APPLICATION FOR CONDITIONAL USE PERMIT

Case No. 1989-14-CUP

HENRY AFRICA'S
DECK & BEACH ADDITION

SITE PLAN REVIEW

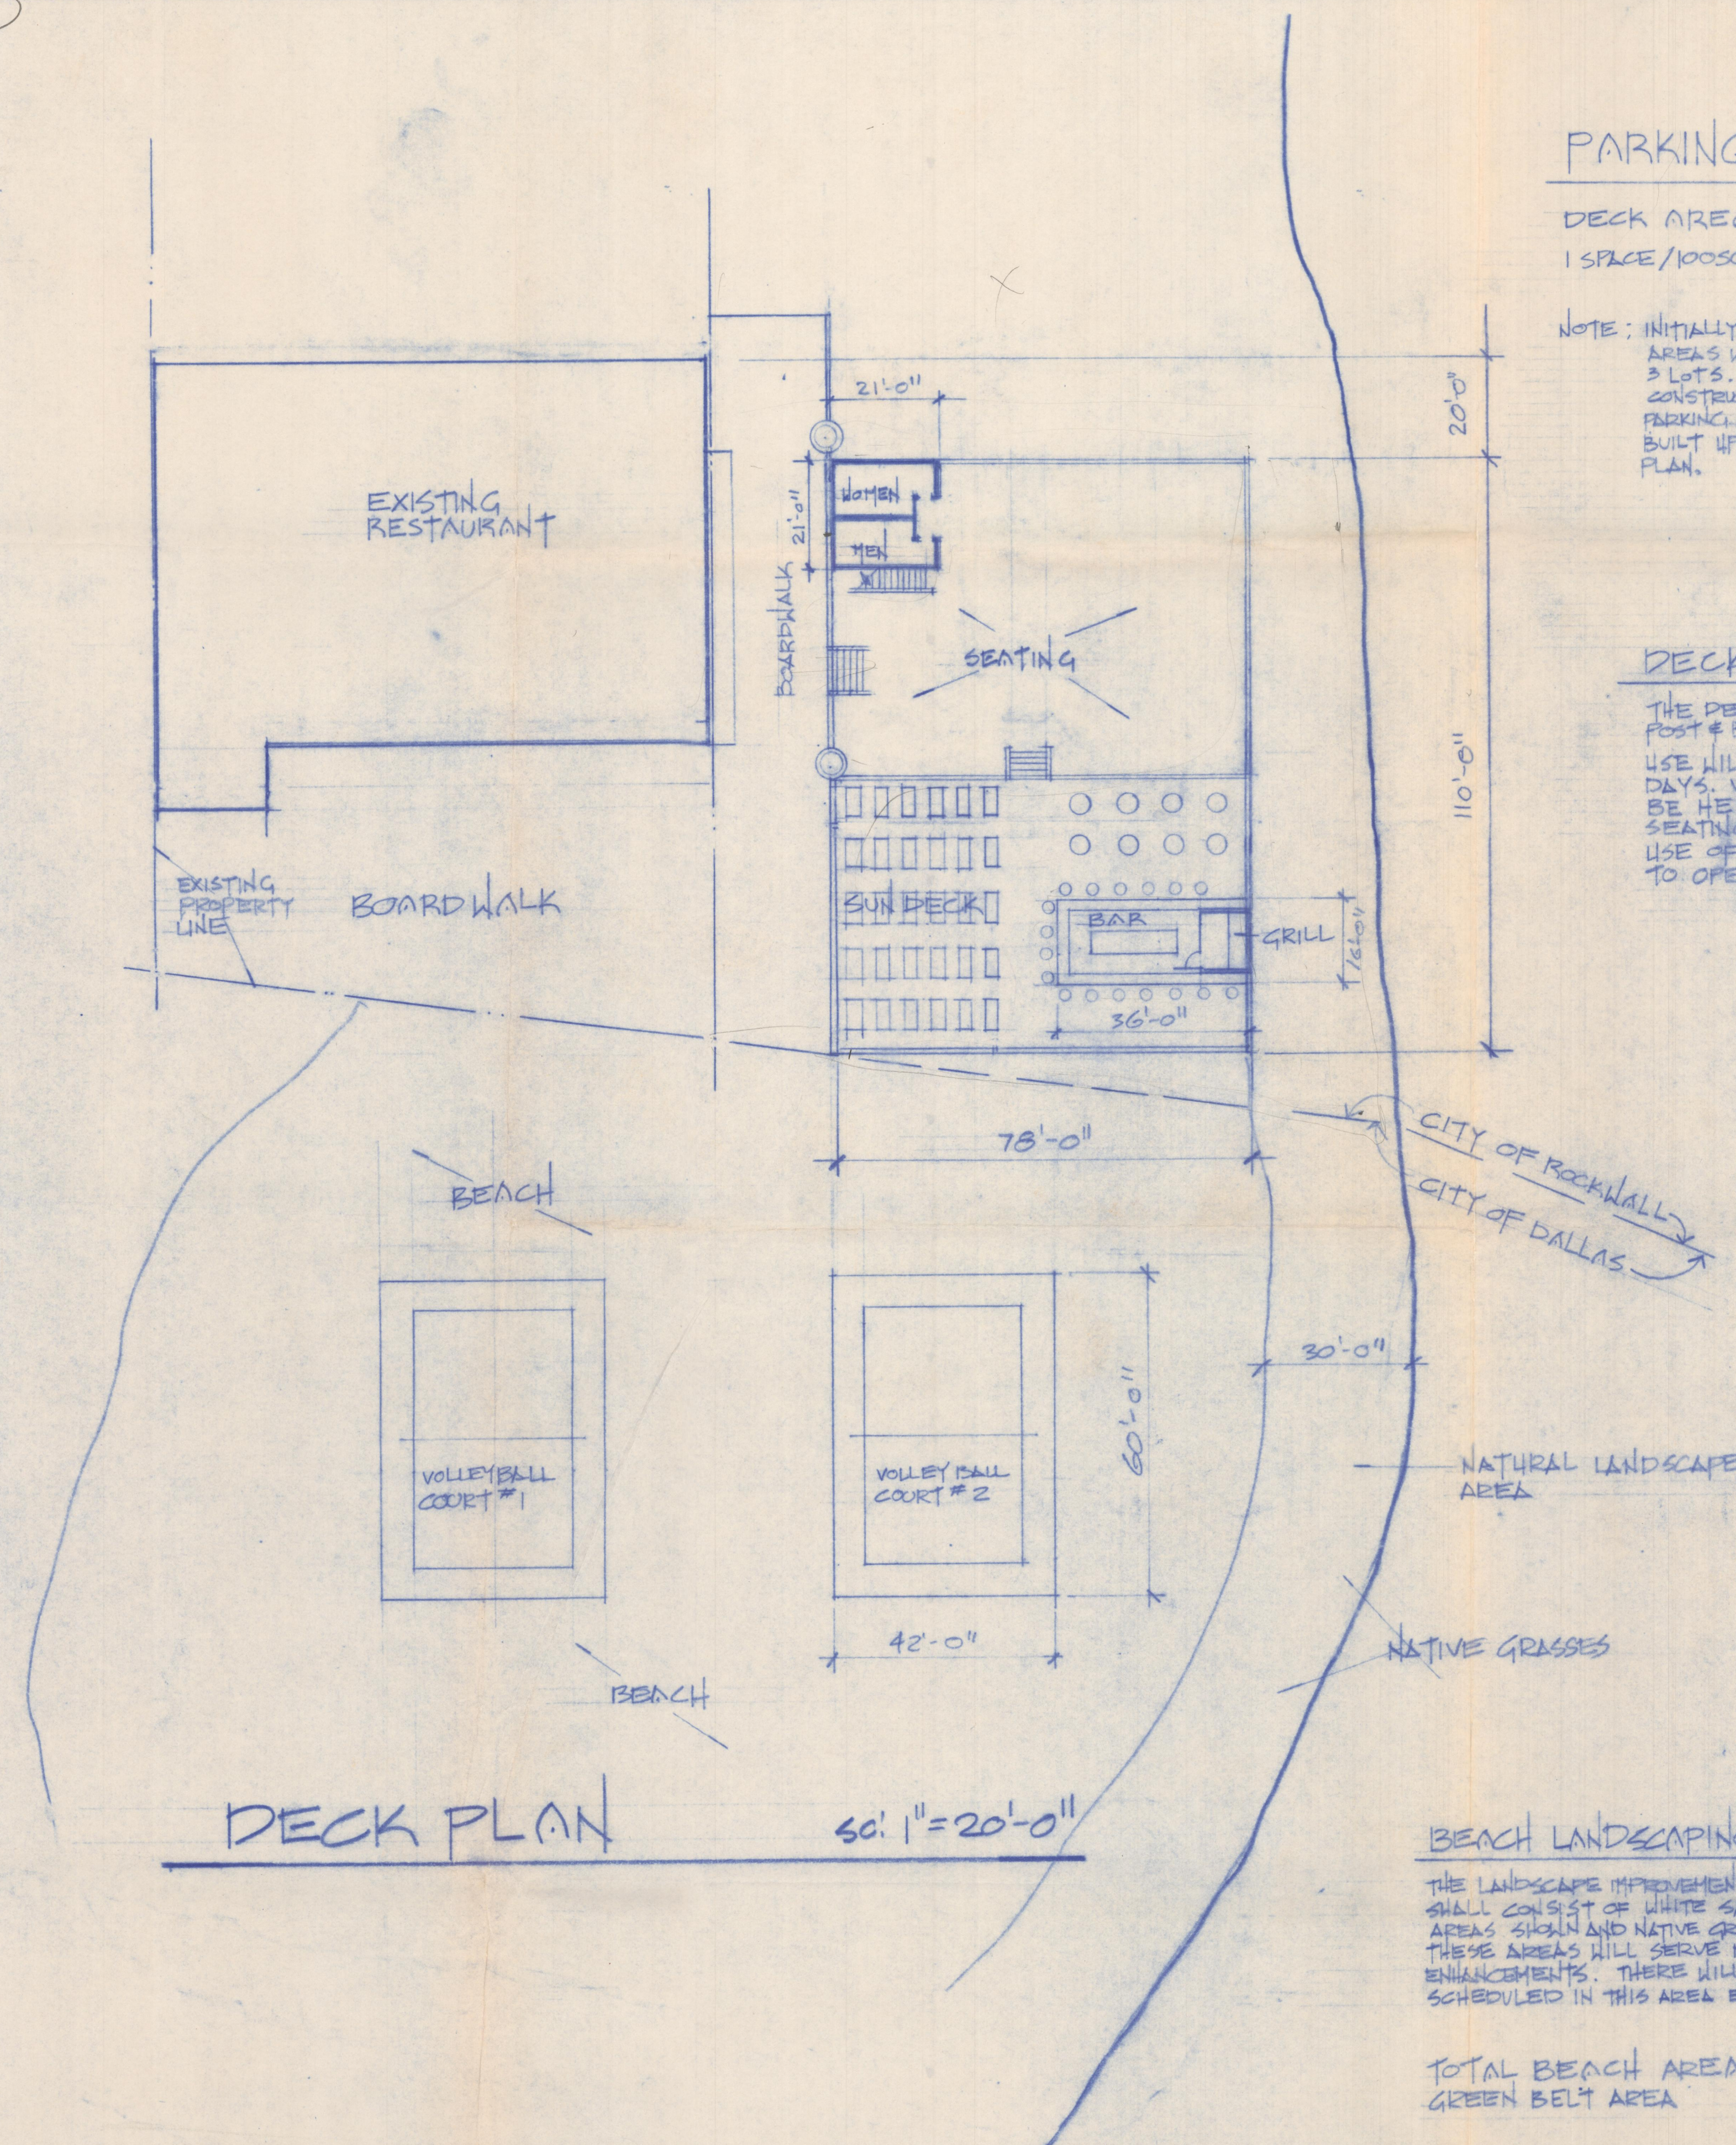
<u>Yes</u>	<u>No</u>	<u>N/A</u>
<u>Planning</u>				
1.	Is the site zoned properly? <u>app has been made</u>	_____	<u>✓</u>	_____
2.	Does the use conform to the Land Use Plan?	<u>✓</u>	_____	_____
3.	Is this project in compliance with the provisions of a Concept Plan?	<u>✓</u>	_____	_____
4.	Is the property platted? <u>has been sub.</u>	_____	<u>✓</u>	_____
5.	Is plat filed of record at Courthouse? File No. _____	_____	_____	_____
6.	If not, is this site plan serving as a preliminary plat?	_____	<u>✓</u>	_____
7.	Does the plan conform to the Comprehensive Zoning Ordinance or PD Ordinance on the following:			
a.	Are setbacks correct?			
	front	<u>✓</u>	_____	_____
	side	<u>✓</u>	_____	_____
	rear	<u>✓</u>	_____	_____
b.	Are buildings on same lot adequately separated?	_____	_____	<u>✓</u>

| h. | Is adequate area in landscaping shown? <i>will have to be added</i> | ☐ | ☒ | ☐ |
| j. | Is landscaping in parking lot required? <i>need detailed plan</i> | ☒ | ☐ | ☒ |
| n. | Are correct number of parking spaces provided? <i>need 75</i> | ☐ | ☒ | ☐ |
| p. | Are parking spaces dimensioned properly? <i>need plan</i> | ☐ | ☐ | ☐ |

- ✓ 1. Landscaping for add. lot area
- ✓ 2. Deck calculation @ 7500 sq ft less grill & Bathrooms? need 75 spaces
3. need access easement for parking.
- ✓ 4. add lot area = ~~15,977~~ 11,088
15% of land = ~~2,228~~ 1,664
= 18' x 110' 1,980
could do something along the deck or provide some planters on the deck
- ✓ 5. need to talk to Ed re: Building ^{code} need structural drawing
all material needs to be loaded/unloaded
6. Signage on deck - restricted to 10% of face area of front of Bldg
need to keep that in mind
- ✓ 7. The parking will be installed at time of construction of deck need detailed plan of parking area - ie adequate landscaping within parking lot if it is permanent
- ✓ 8. need to revise site plan and take off expenses information
- ✓ 9. Road to park goes through parking
- ✓ 10. any ~~music~~ entertainment must be approved by

HENRY AFRICAS
DECK ADDITION

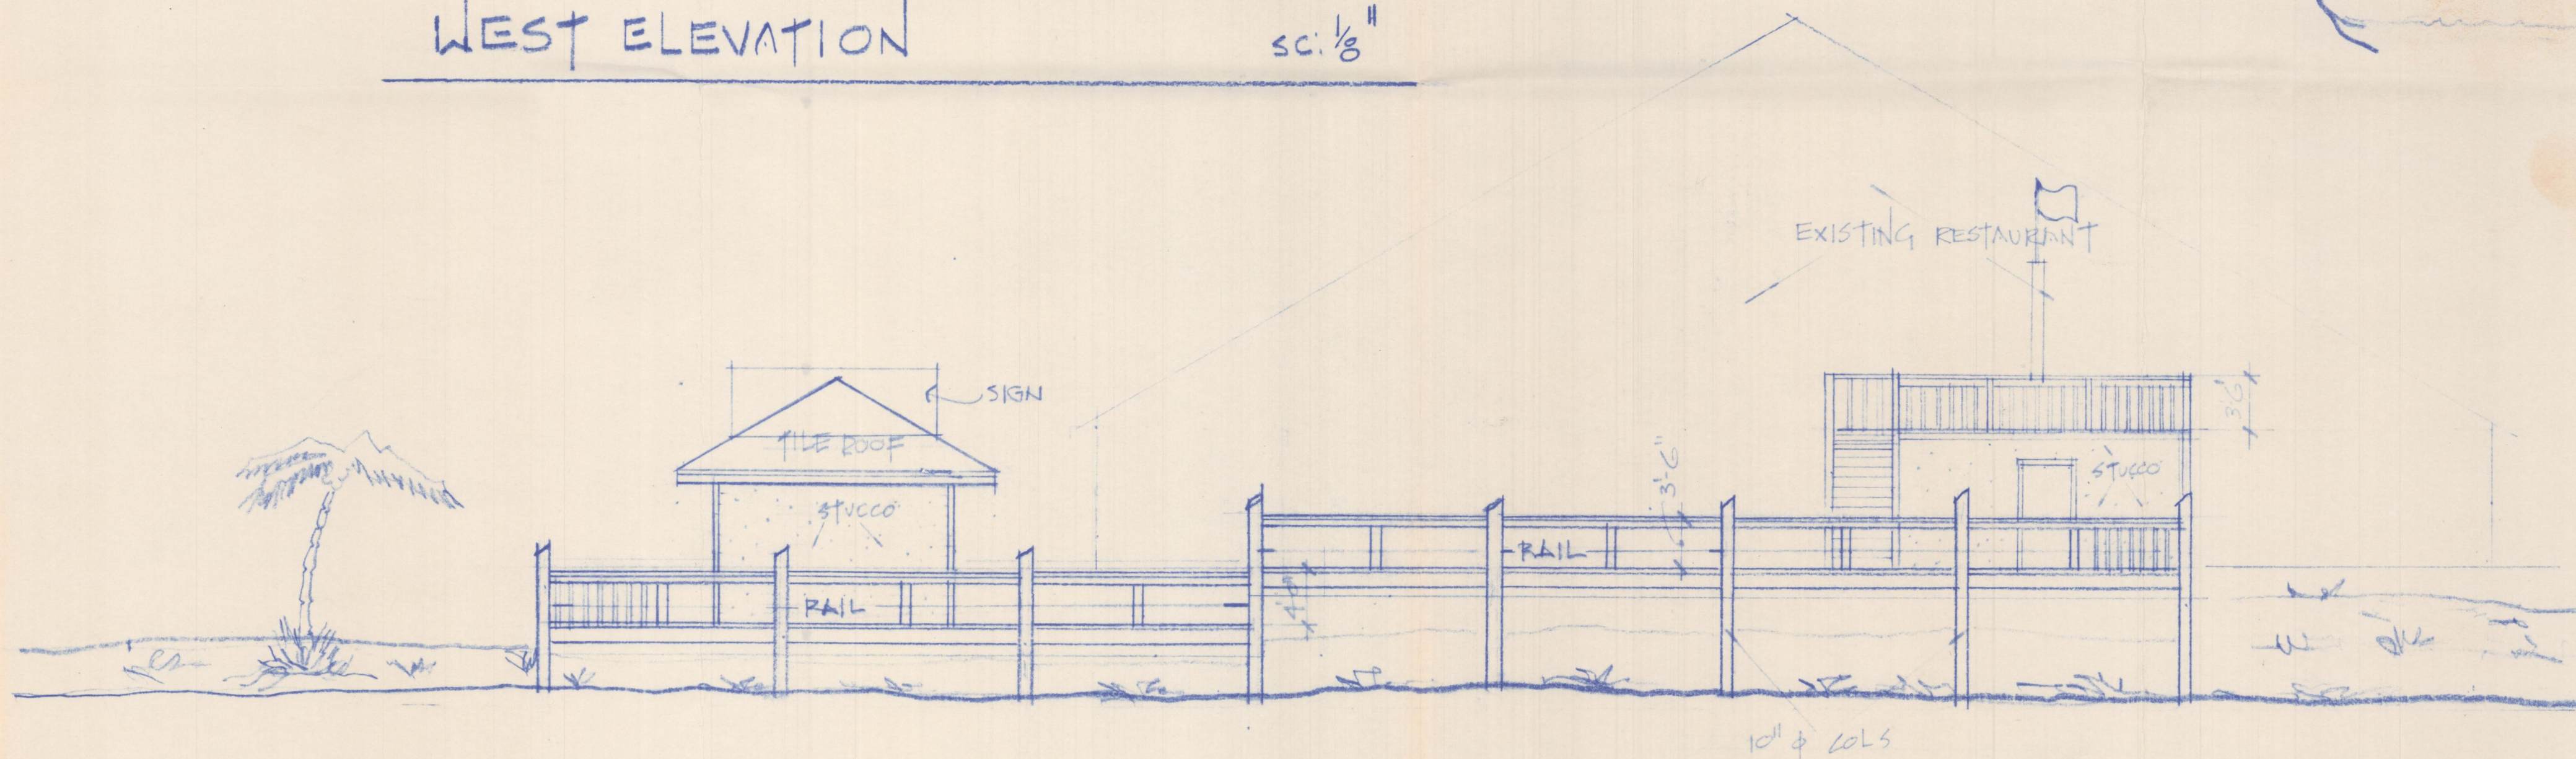
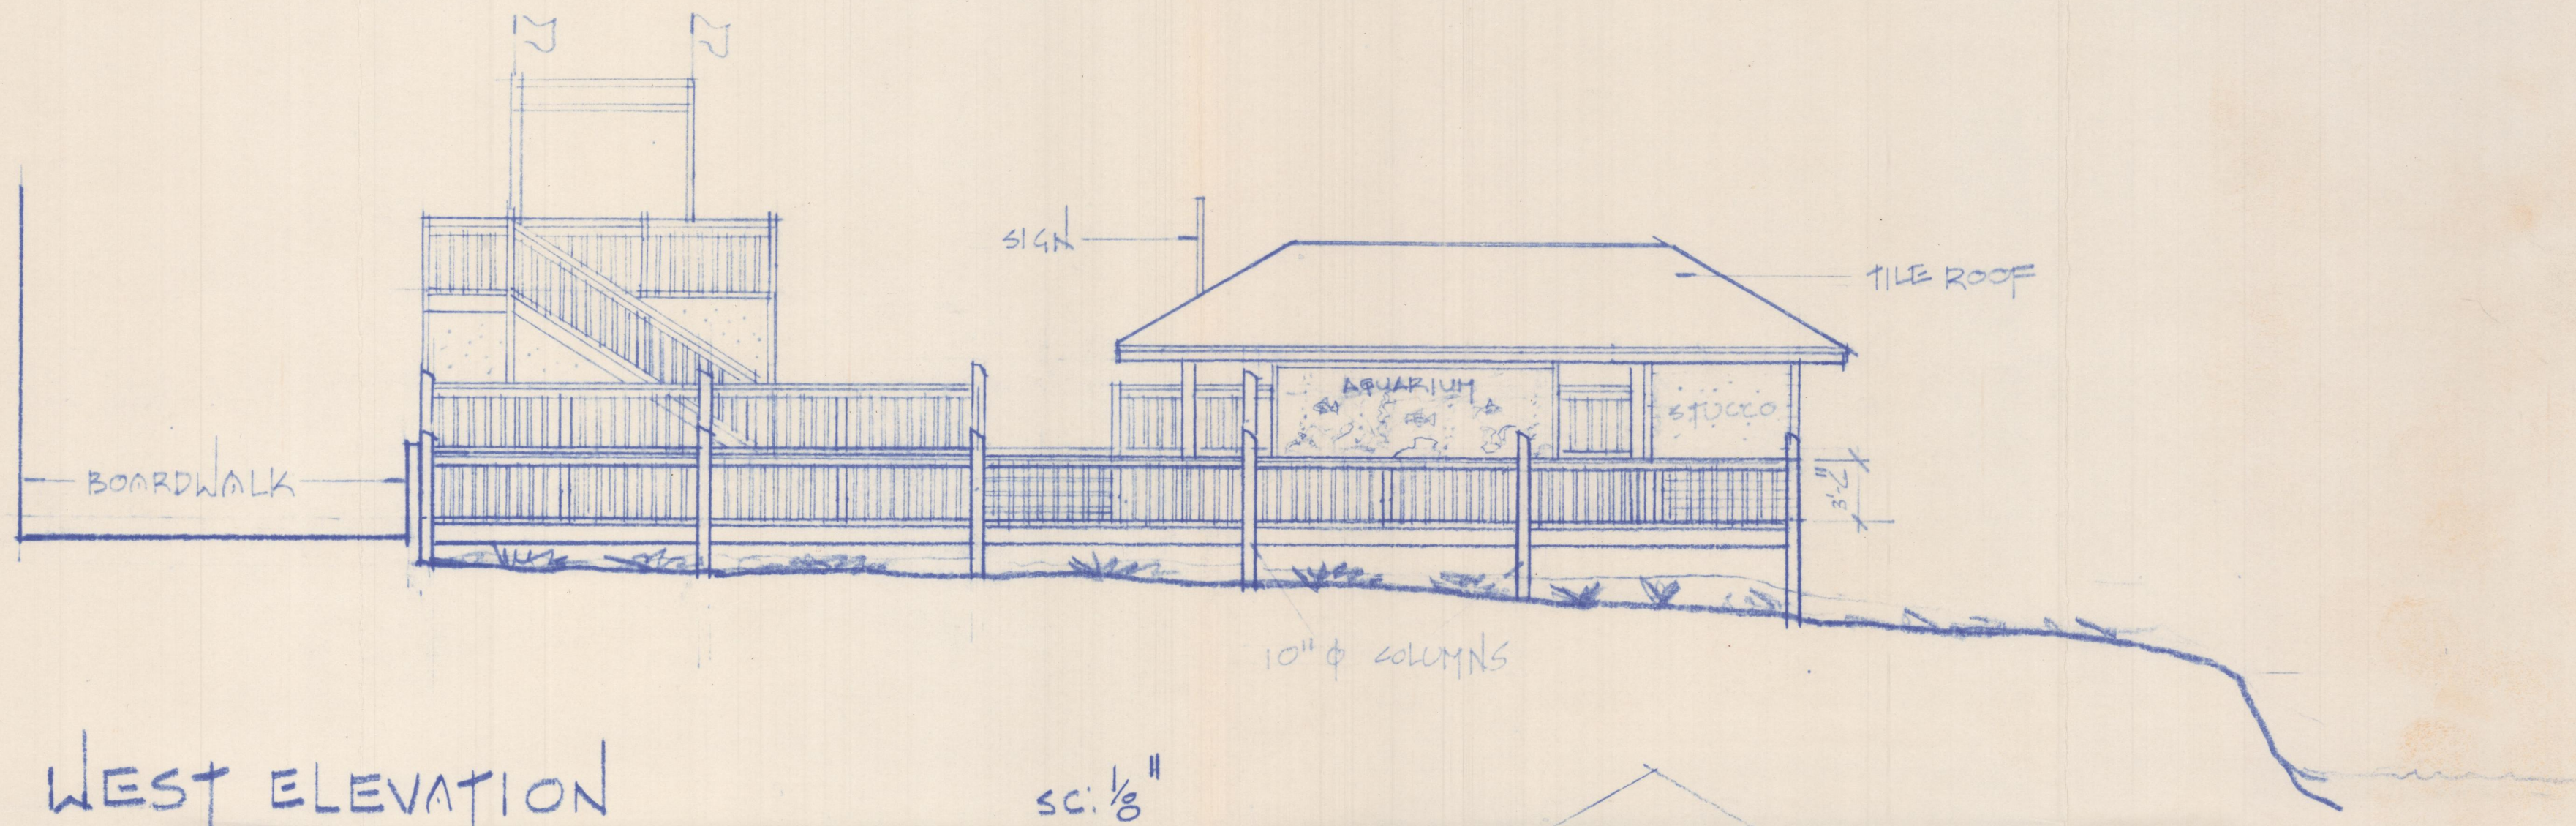
1. Parking has been increased to 82 odd spaces - 3 are relocated
2. Is showing landscaping around deck 940 \$ less than required - what happens as deck is built 390 \$ permanent lands.
3. Have extended some parking along the north property line - gets closer to the restaurant + deck. Parking will be built at time of crst - not as shown on drawing.

questions - 1. type of pavement

2. Easement.

3. Landscaping / irrigation

4. Need to take museum statement off of site plan.

5. Too up plan entertainment

1. add parking + lands.
2. Landscaping
3. Entertainment
- 4.
